<i>Recall Bulletin</i>	<i>RCL-08-004</i>
	<i>DNA</i>

**Subject: Fuel Tank Drain & Breather Hoses**

**Models: Desmosedici RR 2008**

NHTSA CAMPAIGN I.D. Number: 08V-563  
Transport Canada Safety Recall I.D. Number: 08-380

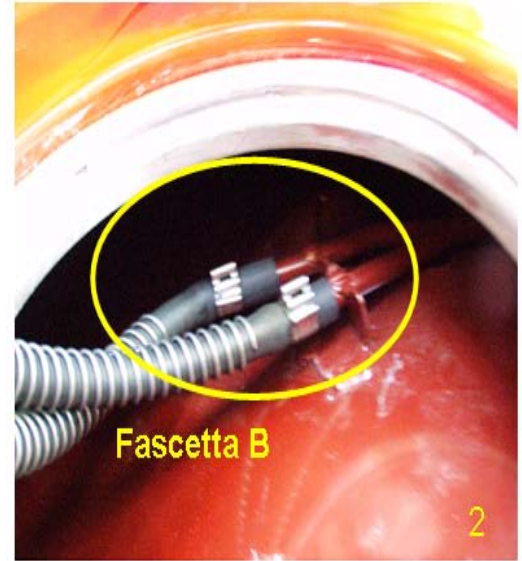
Ducati Motor Holding S.P.A. has determined that the position of the hose clamps on the fuel filler drain hose and fuel breather hose is incorrect, and that the 2 hoses may have become damaged. This can result in a possible fuel leak.

- Install the new drain and breather hoses (part no. 59011581A) to fuel tank and filler flange and reverse the hose clamp positions; hose clamps A (Phillips screw style clamps) (picture 1) removed from the filler flange shall be installed to the tank while hose clamps B (picture 2) shall be replaced with the new ones (part no. 74141001A) and installed to the filler flange.

The fuel filler drain hose and fuel breather hose will be replaced and the hose clamps will be repositioned.

In production, two hoses were replaced with new hoses part no. 59011581A. Two crimp style hose clamps were superseded by hose clamps part no. 74141001A.
